**ADDENDUM No. 1
DOCUMENT 00 91 13-A**

PROJECT: RENOVATION OF DISTRICT 6 WELCOME CENTERS, IN HANCOCK & PEARL RIVER COUNTIES

PROJECT NUMBER: BWO-6070-23(003) / 503755-301000
BWO-6197-55(006) / 503755-302000

HANCOCK WELCOME CENTER FLOOR PLAN

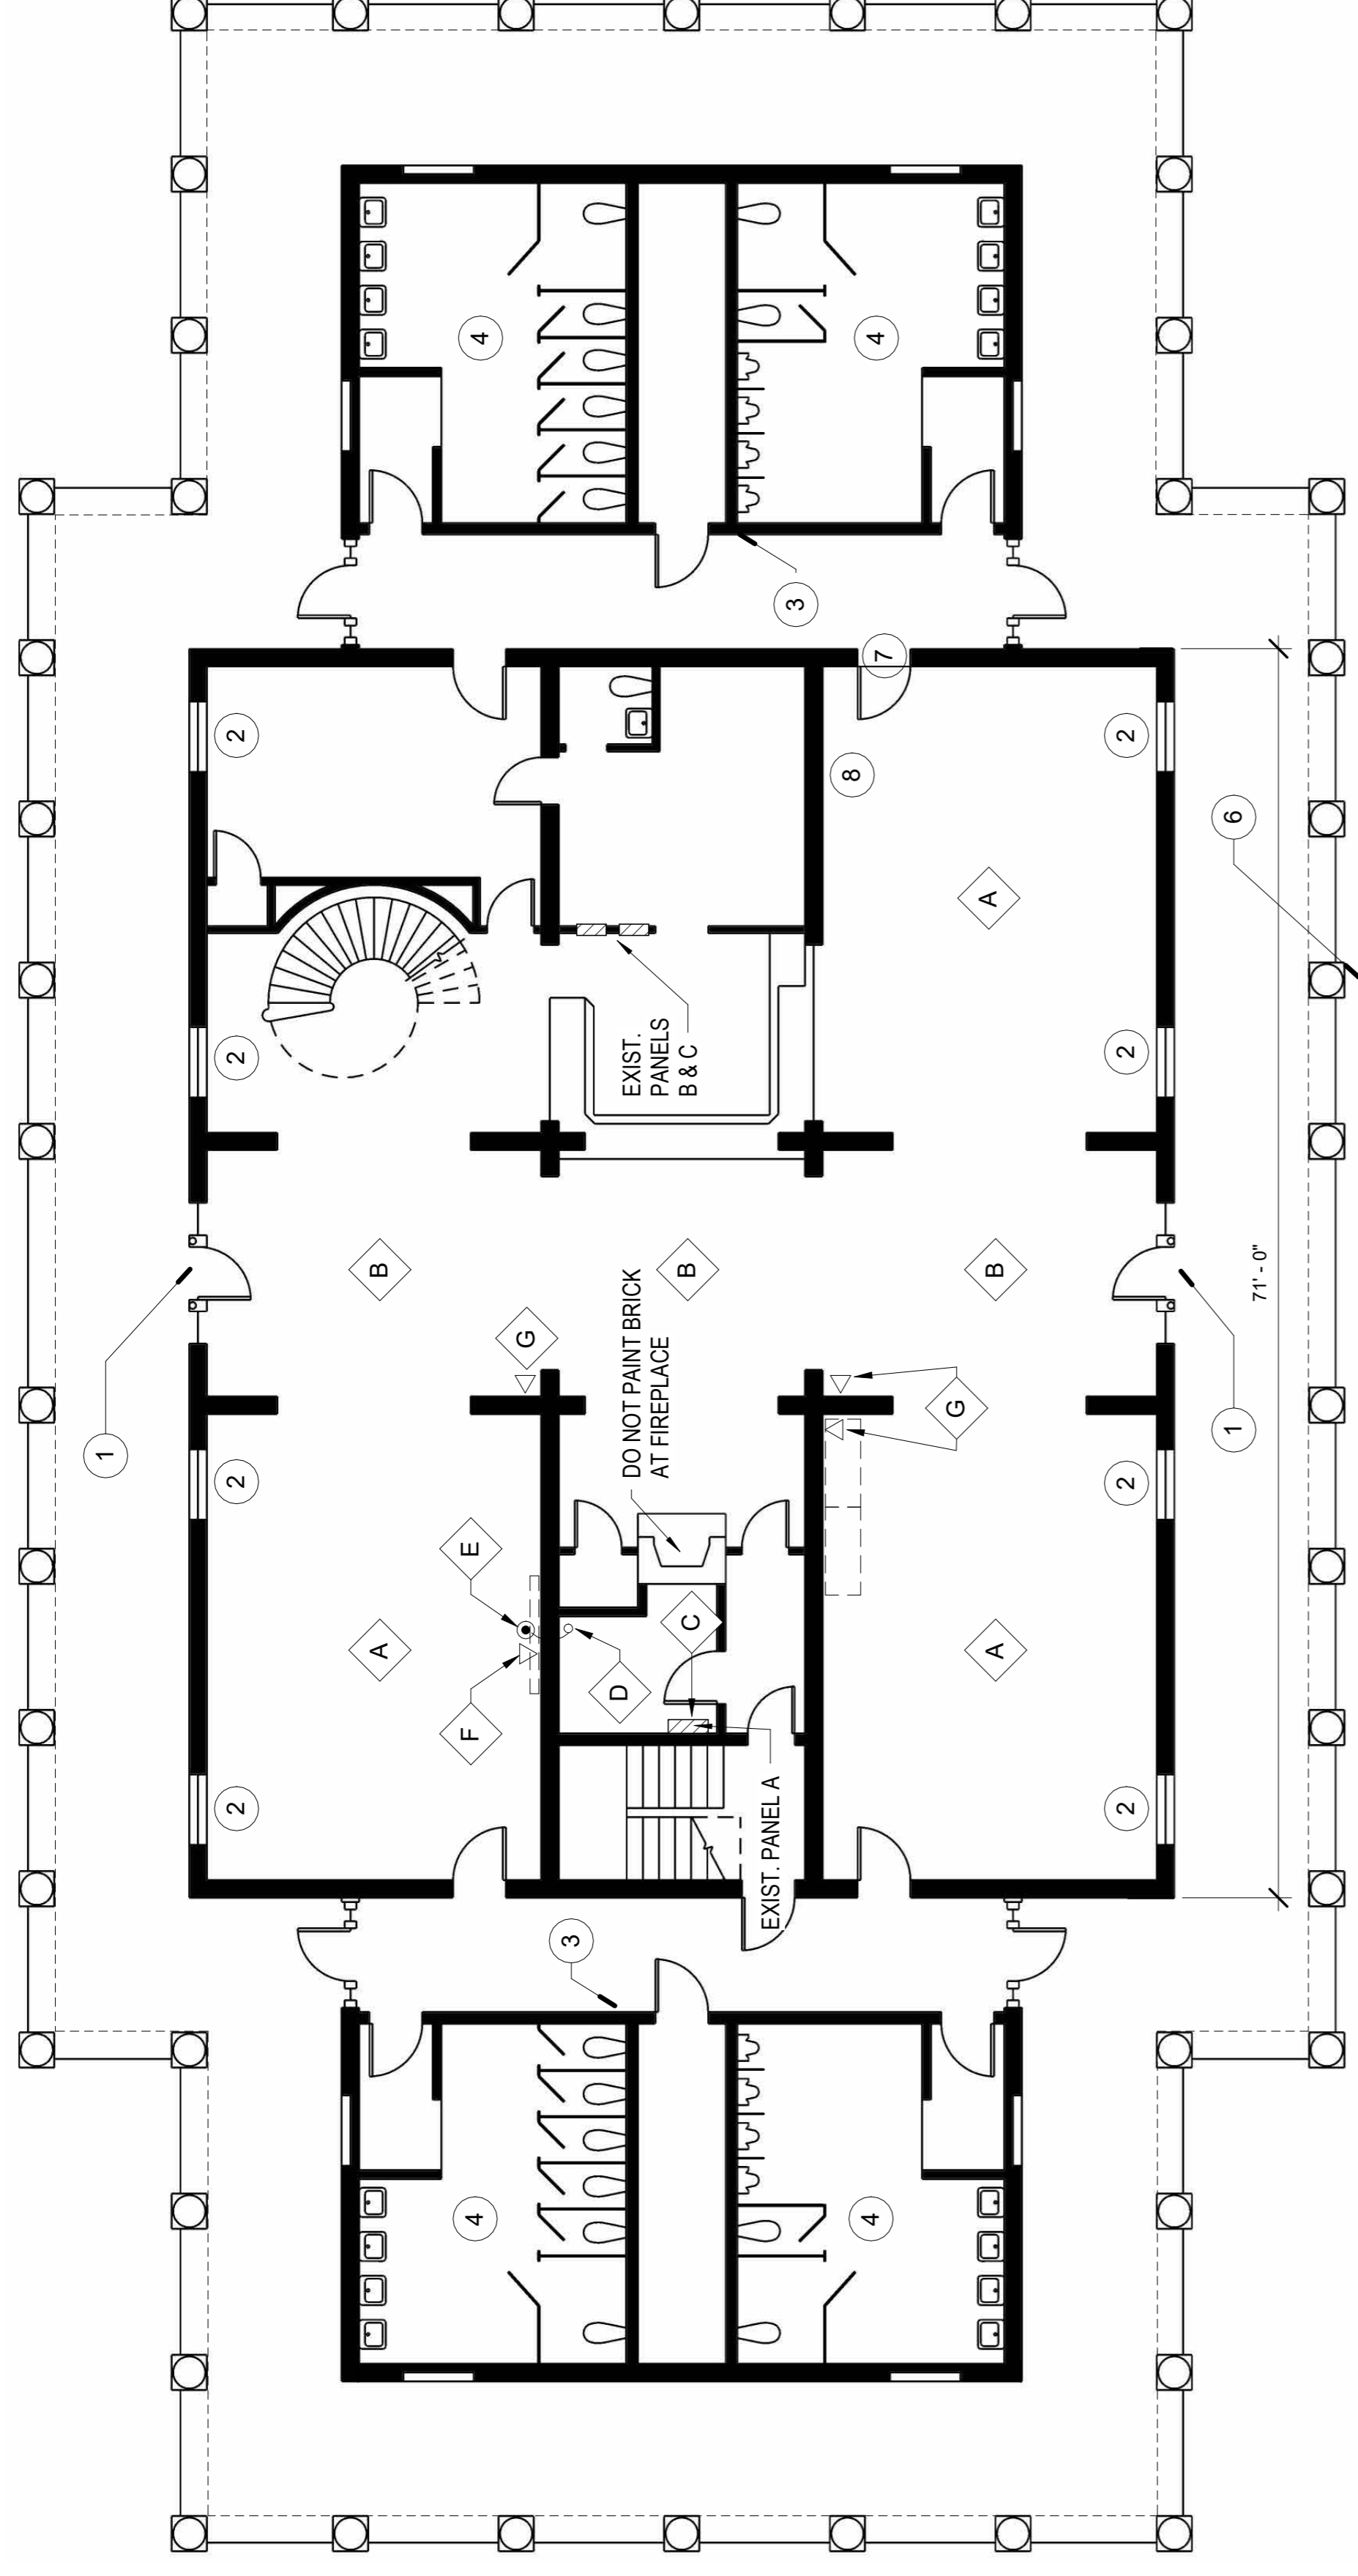
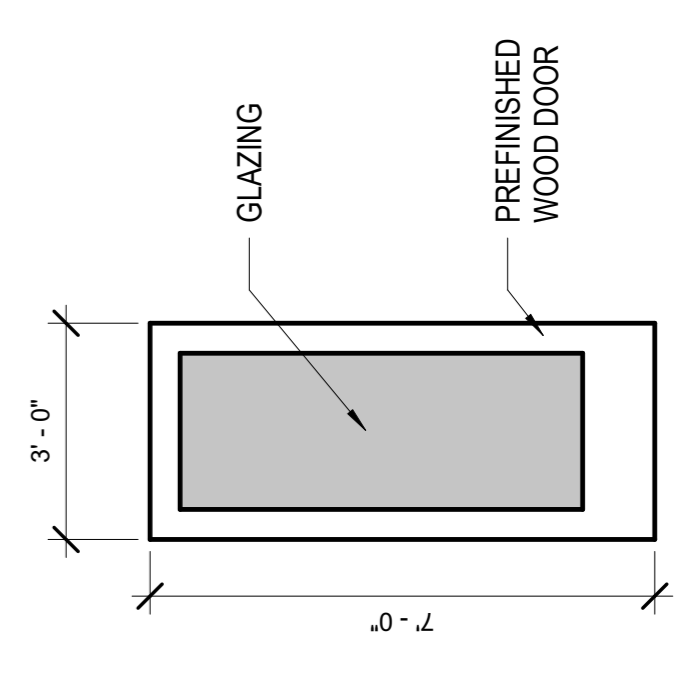
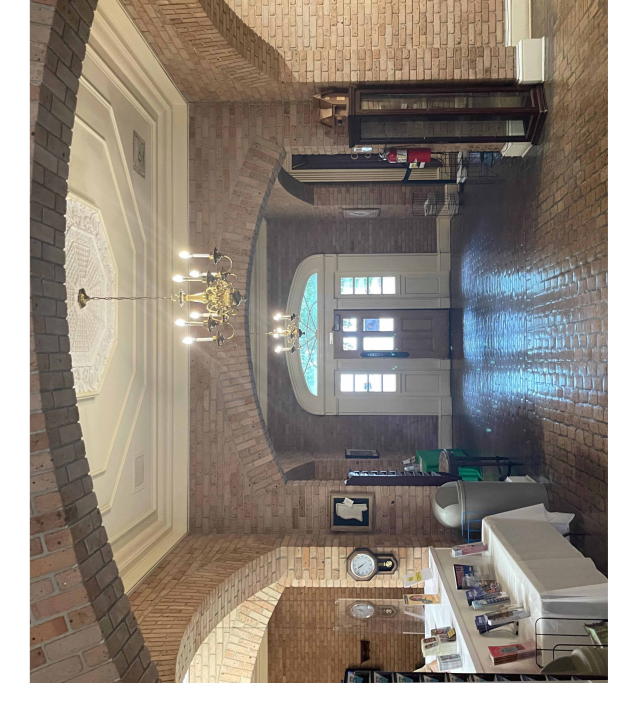
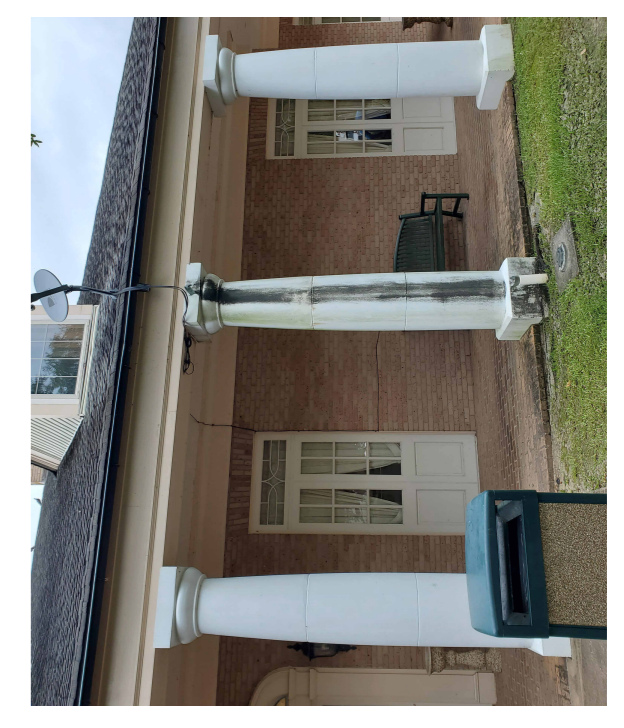
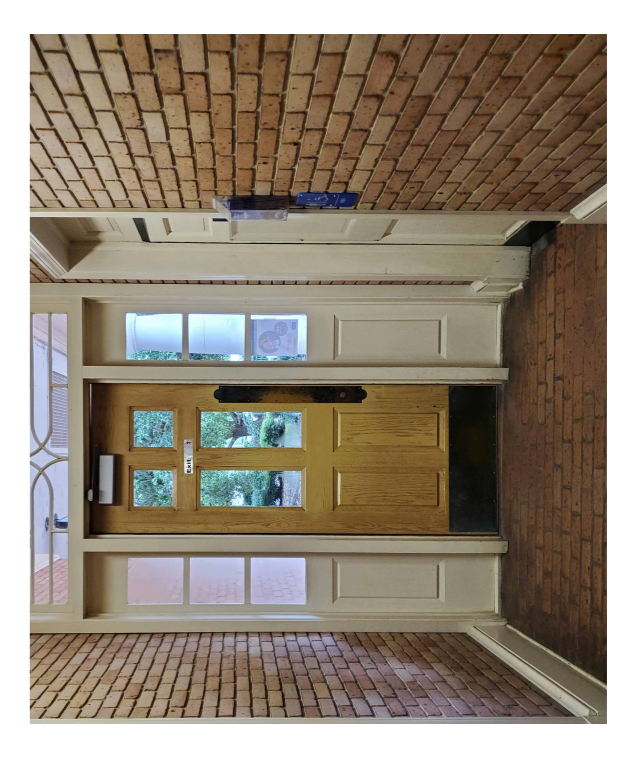
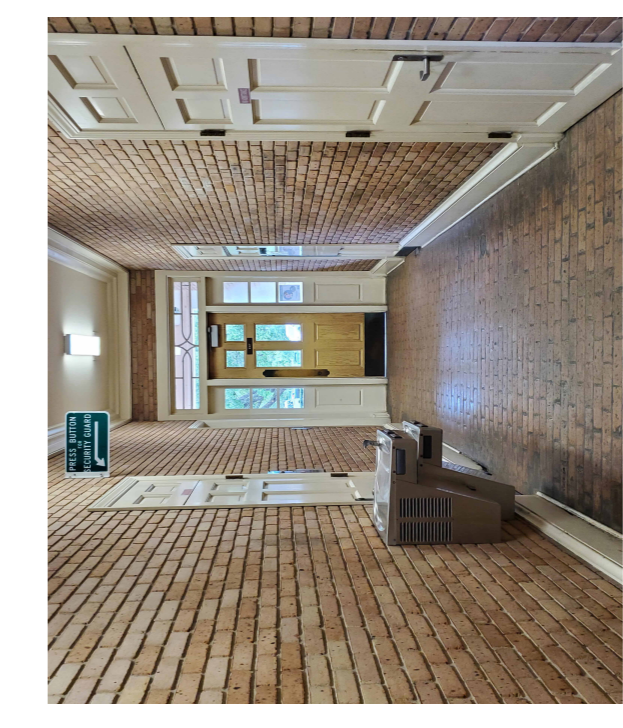
- A. Added Sheet No.1 – Sheet Index
- B. Sheet No. 2, Hancock Keynotes 1,3,5,9,10,13 revised 10-4-24, see revisions.

- 1 REMOVE EXISTING DOOR AND REPLACE WITH NEW FIBERGLASS DOOR AND HARDWARE. SEE SPECIFICATION.
- 2 REMOVE CURTAIN RODS AND PATCH HOLES.
- 3 REPLACE DRINKING FOUNTAINS (OWNER FURNISHED)

- 4 REPLACE TOILET PARTITIONS (IN ALL RESTROOMS) AND URINAL SCREENS (IN MEN'S RESTROOMS). SEE SPECIFICATION.
- 5 PAINT ALL EXISTING WOOD AND FIBERGLASS DOORS. REMOVE HARDWARE. CLEAN AND REUSE. SAND, PRIME, AND PAINT EXISTING DOOR. SEE SPECIFICATION. REINSTALL DOOR AND HARDWARE.

- 8 REMOVE BULLETIN BOARD AND PATCH HOLES.
- 9 PRESSURE WASH EXTERIOR OF BUILDING, INCLUDING PORCH FLOOR. TAKE CARE NOT TO DAMAGE SURFACES. COMPLETELY REMOVE ALL MOLD, MILDEW, AND OTHER FOREIGN SUBSTANCES.

- 10 PRESSURE WASH WELCOME CENTER SIGN, GUARD HOUSE, AND EQUIPMENT ENCLOSURE. TAKE CARE NOT TO DAMAGE SURFACES.
- 11 CLEAN RESTROOM WALL AND FLOOR TILE AND GROUT. PRETREAT ALL GROUT SPOTS AND STAINS. USE CHEMICAL DISINFECTANT AND SHIELDED HIGH PRESSURE CLEANING AND EXTRACTION TO REMOVE ALL FOREIGN SUBSTANCES. THOROUGHLY DRY ALL TILE AREAS AND SEAL FLOOR TILE GROUT WITH LATICRETE STONETECH HEAVY DUTY GROUT SEALER OR APPROVED EQUAL.

- 12 PAINT INTERIOR BRICK WALLS. REFER TO COLOR DESIGN SPECIFICATION AND PAINT SPECIFICATION
- 13 PAINT ALL PREVIOUSLY PAINTED INTERIOR SURFACES ON FIRST FLOOR. PAINT ALL PREVIOUSLY PAINTED SURFACES UP TO AND INCLUDING SPIRAL STAIRCASE LANDING. PAINT WALLPAPER WAINSCOT AT LANDING. THE REMAINDER OF THE SECOND FLOOR IS EXCLUDED FROM THE LIMITS OF WORK. REFER TO COLOR DESIGN SPECIFICATION AND PAINT SPECIFICATION

PEARL RIVER CO.
 WELCOME CENTER
 BUILDING

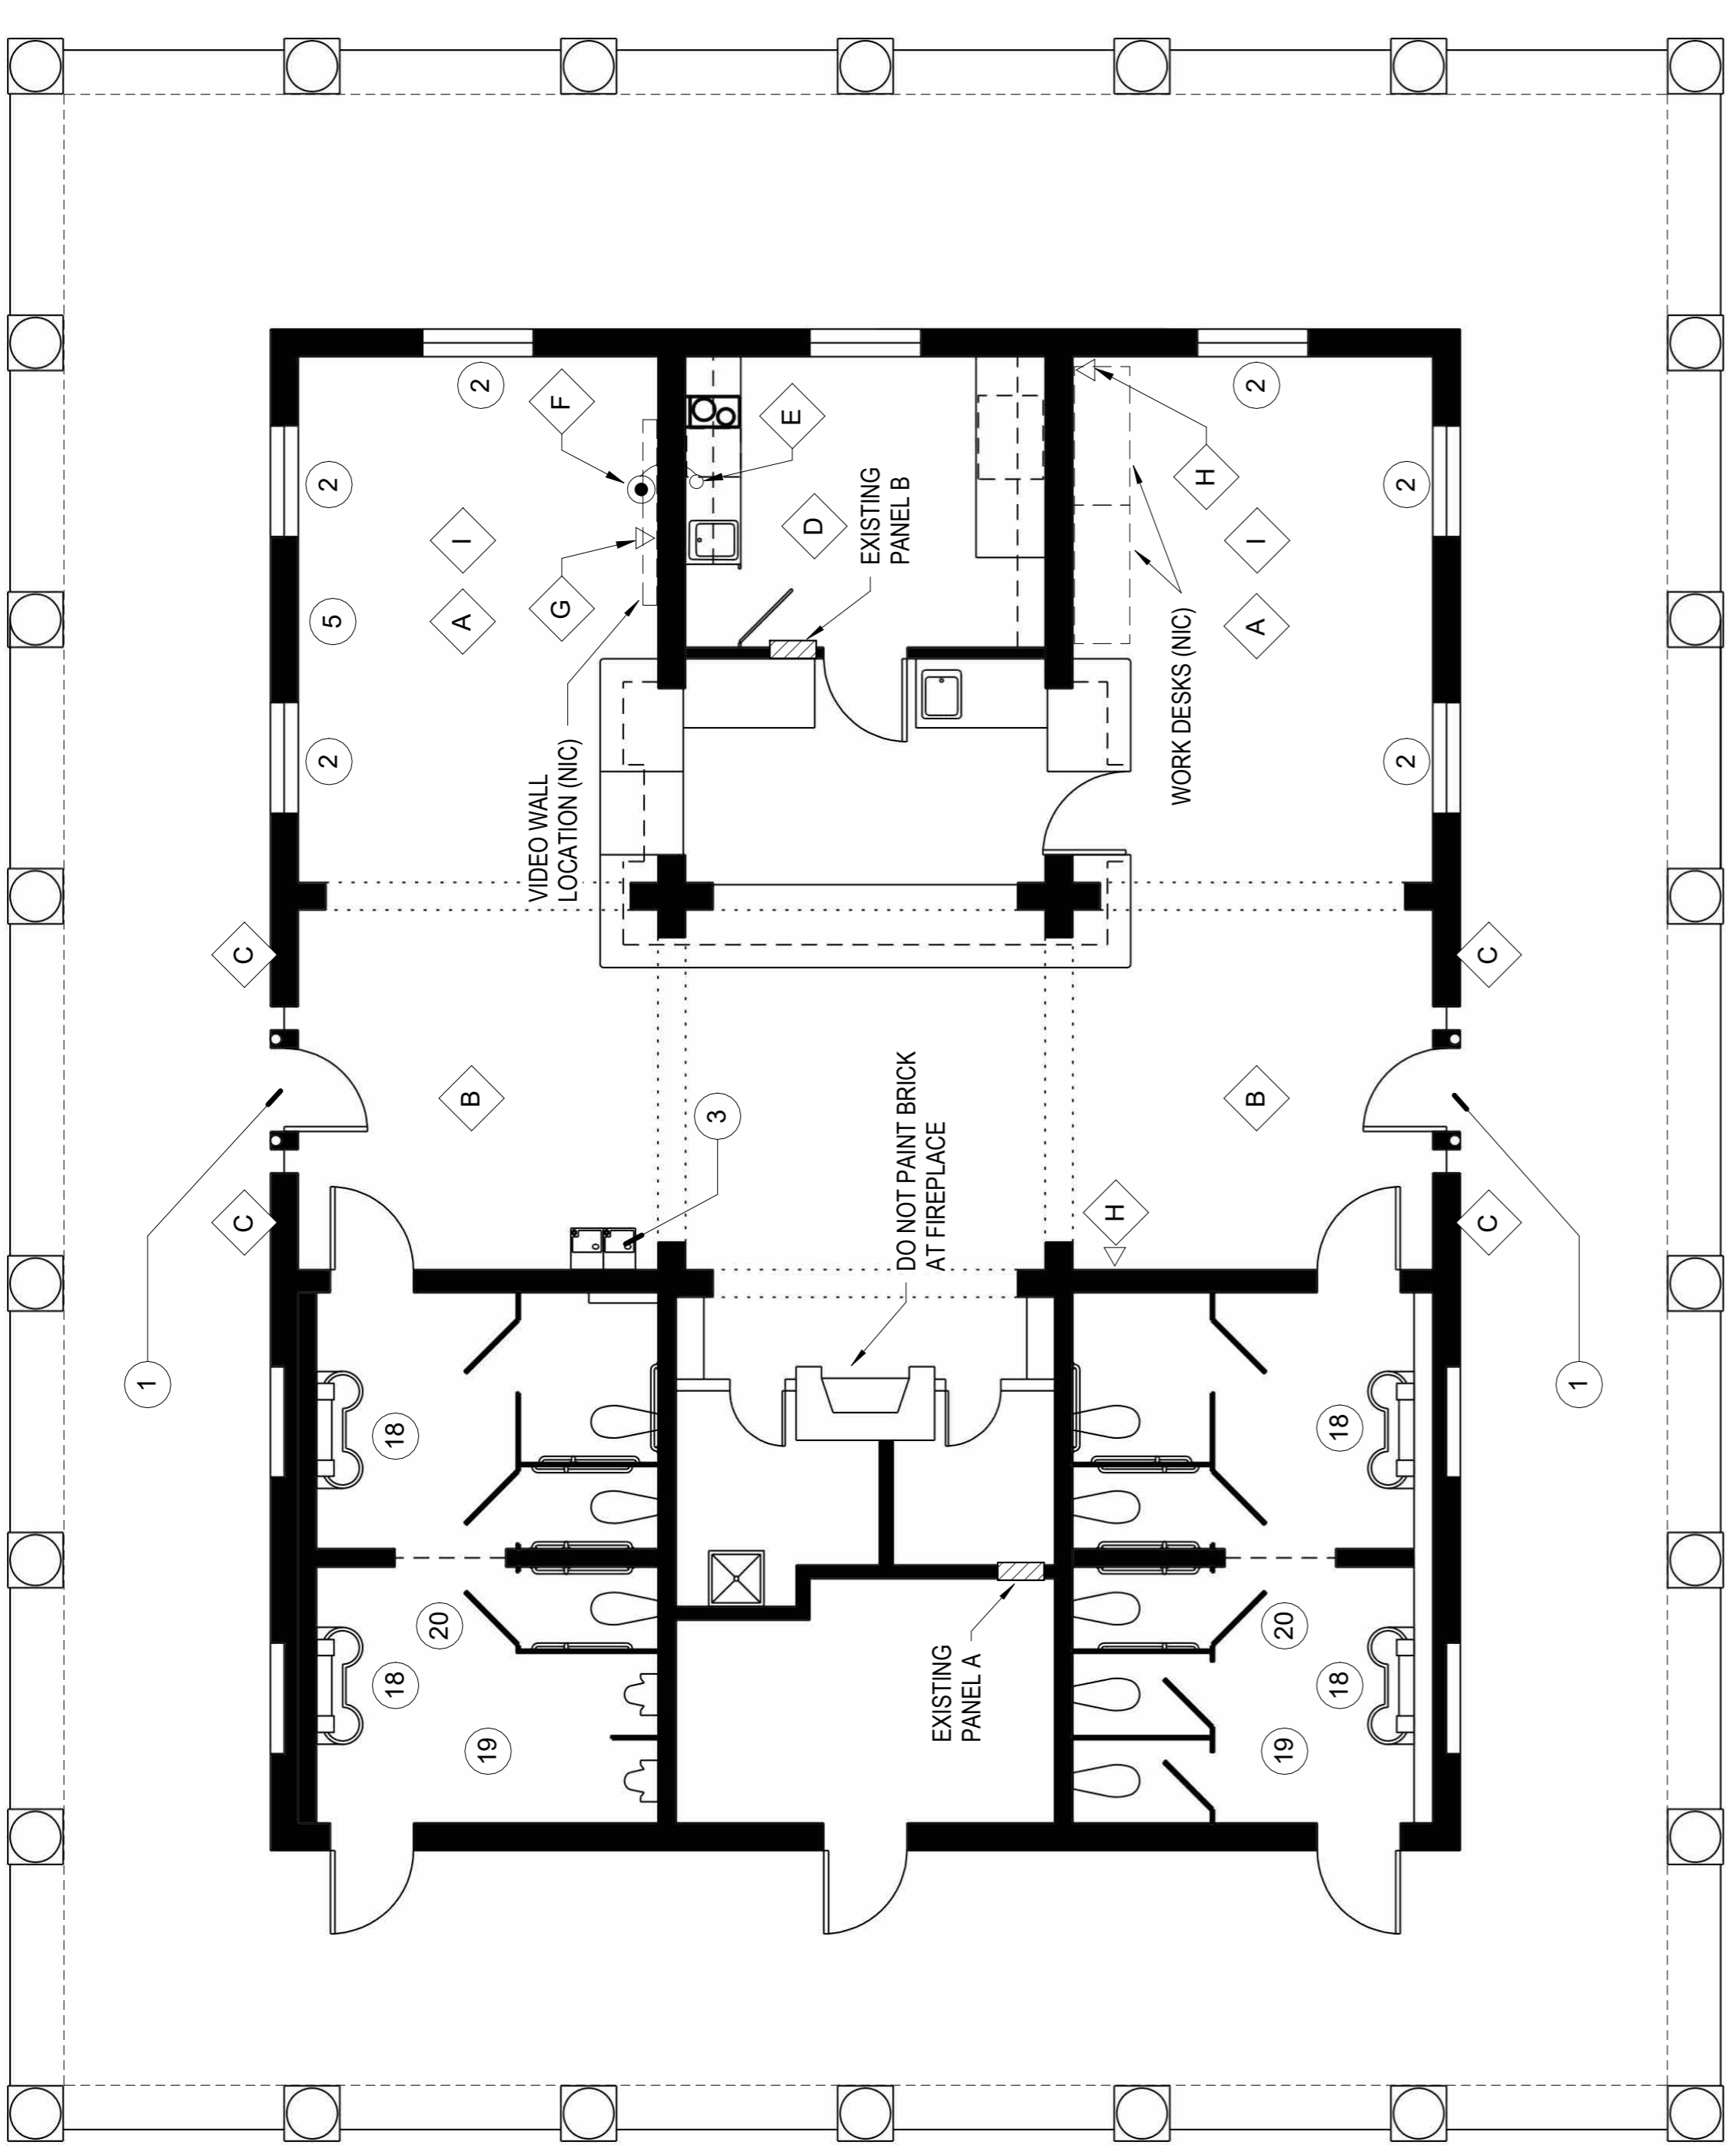
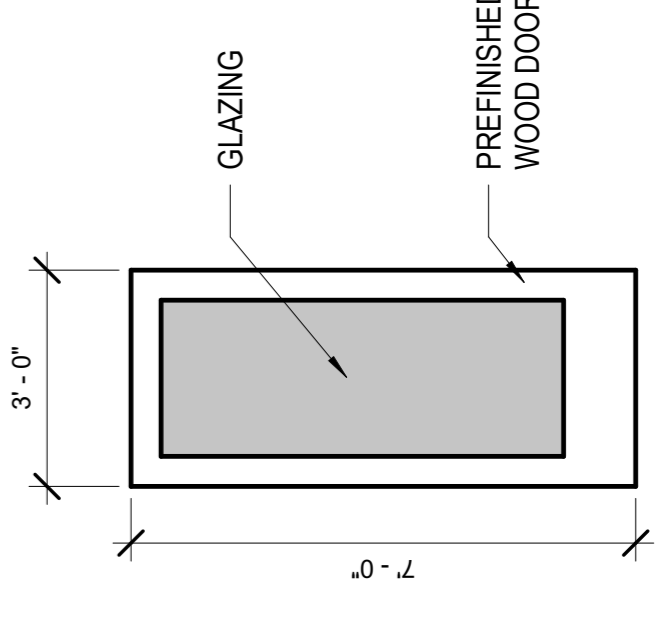
- C. Sheet No. 3, Pearl River Notes 1,3,4,6,7,12,18,19,20 revised 10-4-24, see revisions.

- 1 REMOVE EXISTING DOOR AND REPLACE WITH NEW FIBERGLASS DOOR AND HARDWARE. SEE SPECIFICATION.
- 2 REMOVE CURTAIN RODS AND PATCH HOLES.
- 3 REPLACE DRINKING FOUNTAINS (OWNER FURNISHED). REMOVE SOLID SURFACE BACKSLASH. PATCH AND REPAIR BRICK AS REQUIRED PRIOR TO PAINTING.

- 4 PAINT ALL EXISTING WOOD AND FIBERGLASS DOORS. REMOVE HARDWARE. CLEAN, AND REUSE. SAND, PRIME, AND PAINT EXISTING DOOR. SEE SPECIFICATION. REINSTALL DOOR AND HARDWARE.

- 5 REMOVE BULLETIN BOARD AND PATCH HOLES.
- 6 PRESSURE WASH EXTERIOR OF BUILDING, INCLUDING PORCH FLOOR. TAKE CARE NOT TO DAMAGE SURFACES. COMPLETELY REMOVE ALL MOLD, MILDEW, AND OTHER FOREIGN SUBSTANCES.

- 7 PAINT ALL PREVIOUSLY PAINTED/STAINED/PIPKLED SURFACES (INTERIOR AND EXTERIOR). REFER TO COLOR DESIGN SPECIFICATION AND PAINT SPECIFICATION
- 8 CAULK WINDOWS AND RE-PUTTY MUNTINS AT GLAZING AS NEEDED.

- 12 PRESSURE WASH PICNIC PAVILIONS AND GUARD HOUSE. PAINT ALL PREVIOUSLY PAINTED INTERIOR AND EXTERIOR SURFACES.
- 13 INSTALL NEW LITERATURE RACKS AS DIRECTED. (OWNER FURNISHED)

- 18 REPLACE EXISTING HANDWASHING STATION (4 IN TOTAL) WITH BRADLEY GLX-2 WITH VERGE METRO FAUCETS OR APPROVED EQUAL. FAUCET SENSORS TO BE CONNECTED TO HOUSE POWER. SUBMIT PRODUCT DATA FOR REVIEW.

- 19 REPLACE FOUR (4) HAND DRYERS (PER RESTROOM) WITH BRADLEY MODEL 2923-28W001 OR APPROVED EQUAL.
- 20 REPLACE FOUR (4) 24" X 36" MIRRORS (PER RESTROOM) WITH BRADLEY MODEL 781 OR APPROVED EQUAL.
